Development Management Case Officer Report

Application Ref: LA06/2020/0097/F | **DEA:** Bangor Central

Proposal:

Recommendation: Grant Planning Permission

Figure 22 – Proposed Queen’s Parade Elevation showing transition between existing and proposed buildings

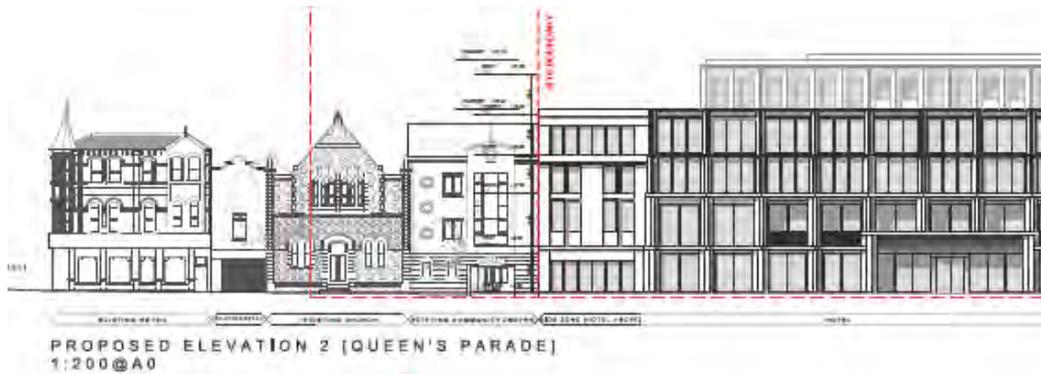
- The proposed building heights along Queen’s Parade will be between four and five storeys. This will be slightly higher than the buildings approved under the previous application which were between three and four storeys. The majority of the existing buildings along Queen’s Parade are three storey, however the application proposes to demolish a number of these to make way for new development, leaving only some of the existing buildings at the eastern end of Queen’s Parade. The development therefore proposes an entirely new frontage to the majority of Queen’s Parade which provides an opportunity for the introduction of slightly taller buildings and a fresh design approach. The above criteria specifies that development on Queen’s Parade should be consistent with the height of existing buildings. The scheme has been designed so that the building immediately adjacent to the remaining buildings on Queen’s Parade will step up gradually in height to ensure there is an appropriate transition between the existing and proposed buildings.

The proposals initially submitted with the application included an additional storey on the proposed block at the western side of ‘The Market Place’. This height was considered to be unacceptable and overly dominant within the existing townscape setting and following discussions with the applicant and agent, was removed from the scheme. It is considered that the four to five storey height of the proposed buildings on Queen’s Parade will not cause any unacceptable harm to the character or appearance of the town centre. Queen’s Parade is one of the key frontages of the town centre due to its orientation facing the coast and its high level of visibility from many viewpoints within the town centre and around the bay. Being located at such a key position within the town centre, it is considered that taller, landmark buildings are appropriate. In

Figure 46 – Original proposed Queen’s Parade elevation showing roof plant on hotel and cinema buildings prior to amendments

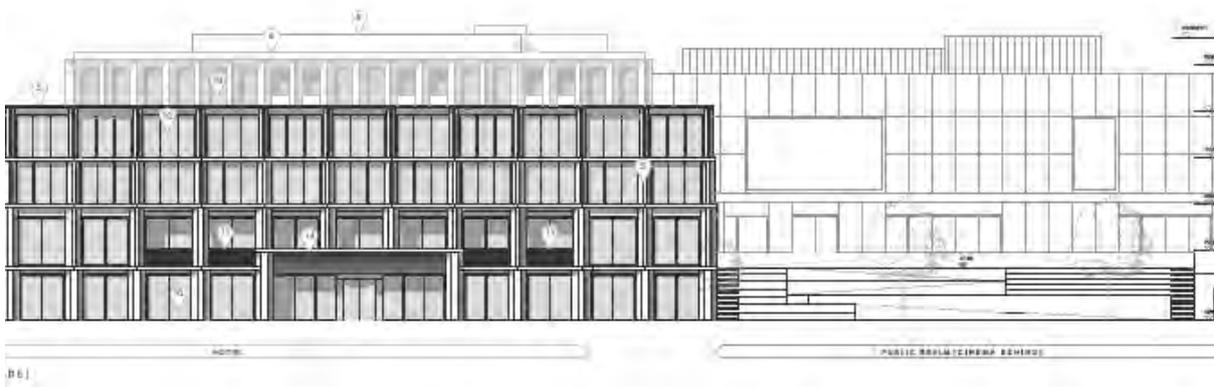
- Cinema – The higher portion of the plant screening at the front of the building has been dropped in line with the ridge level of the auditorium volume so that the plant screen now blends with the roof of the building and will also be finished in the same metal rain screen cladding as the rest of the roof, thereby reducing its visual impact.
- Office Building – The architect has assured the Council that the plant room for the office building will be barely visible. One of the main views of the building is shown in the CGI image below in Figure 45. It was agreed that given the significant set back and comparatively smaller size of this plant room, no amendments would be required. The plant will only be seen from very long-distance views.

10.74 Approval would be subject to conditions stipulating that the height of the plant rooms and screens must not exceed that shown on the submitted plans and that no plant shall be installed until the final specification of materials and finishes for the plant rooms and screens have been agreed in writing with the Council.

Figure 64 – CGI image showing amended roof treatment to office block and hotel

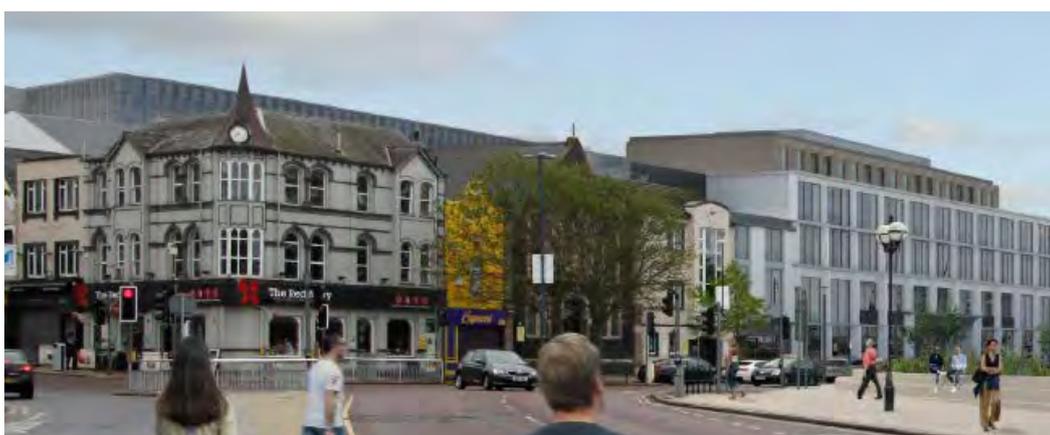
10.98 Another concern raised by the Council was the massing and height of the office block and its resulting dominance which will be visible protruding above the Red Berry Café building. The Council emphasised that the buildings on Queen's Parade should remain predominant and that any new buildings to the rear should appear subordinate or at least follow the established built form which rises up gradually along Main Street. The agent advised that it would not be possible to reduce the height of the office building as the developer requires a certain amount of office floor space. Instead, the architects amended the design to provide a simplified more lightweight glazed approach with finer parapet detailing to reduce the bulky appearance. Two elements on the roofs of the office building and the hotel as indicated by the red arrows in figure 63 below were also removed again to reduce the bulk on the roof and to provide a more streamlined appearance.

Figure 79 – Aerial image showing location of Clandeboye Lake (demoted by blue star) and Queen's Parade (demoted by red star)

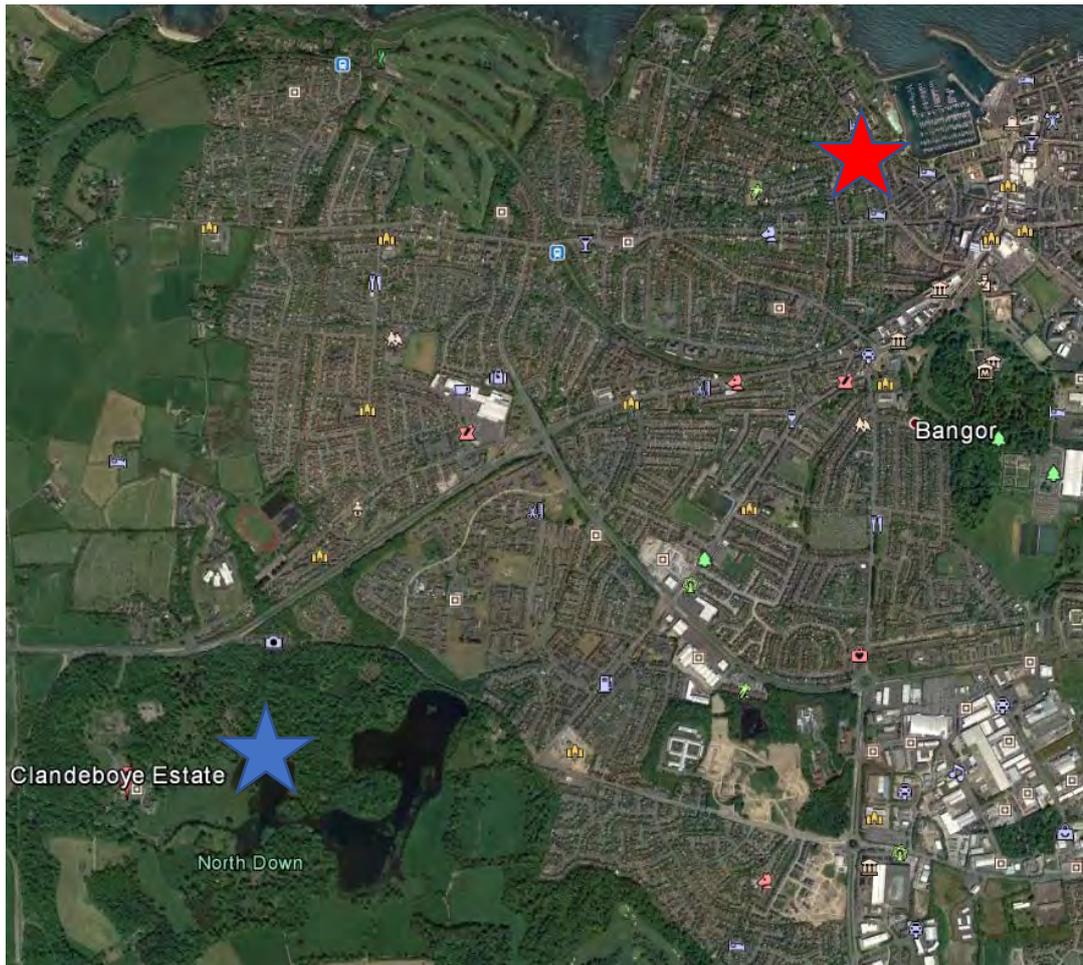
rating at this site is considered high. This is therefore considered by DfI Rivers to be an **unacceptable** combination of depth and velocity for this particular development proposal.

10.135 As stated above, a consultation response is one of many material considerations (including the previous approval which only expired in July 2020) to be balanced in the assessment of any planning proposal. In this case the reservoir of concern is located more than 2.6 km away from the site. The flood map has been modelled on a worst-case scenario of the collapse of Clandeboye Lake.

Figure 80 – Blue highlighted area denotes indicative area that may flood from an uncontrolled release of water from all possible dam failure scenarios (DFI Reservoir Flooding Map for Emergency Planning)

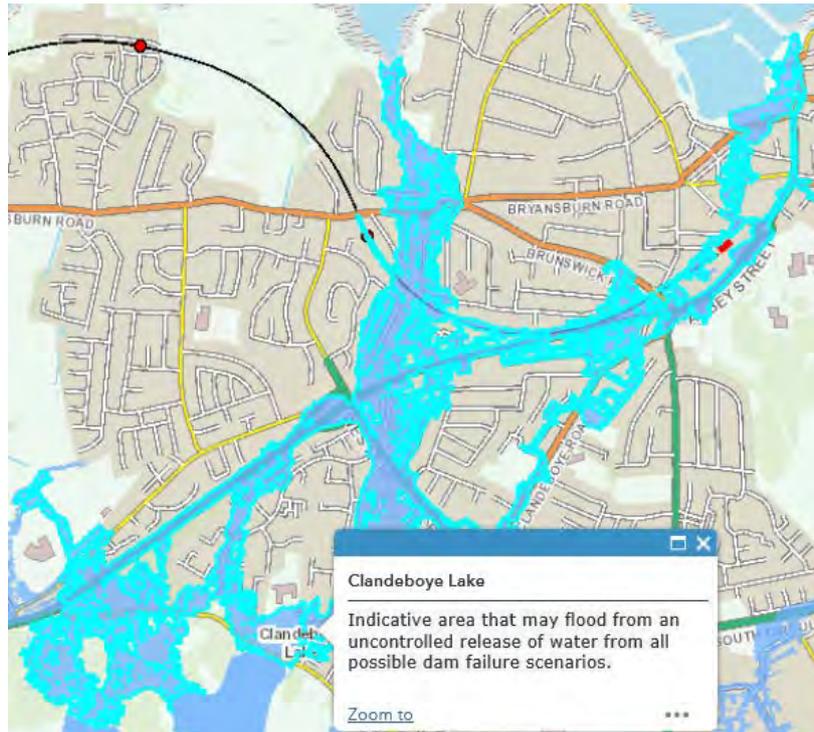
- 10.136 The application site lies within an area where the submitted FRA has indicated certain areas having potential for an unacceptable combination of depth and velocity. The text at paragraph 6.61 of PPS 15 refers to a presumption against development rather than an outright ban or moratorium. As accepted by the Planning Appeals Commission in appeal decision 2018/A0098, the use of the word 'presumption' is not an absolute term and suggests that there could still be instances where a decision to approve a proposal might be acceptable. Also such an inundation is shown above to affect a large proportion of Bangor rather than just part of the application site.
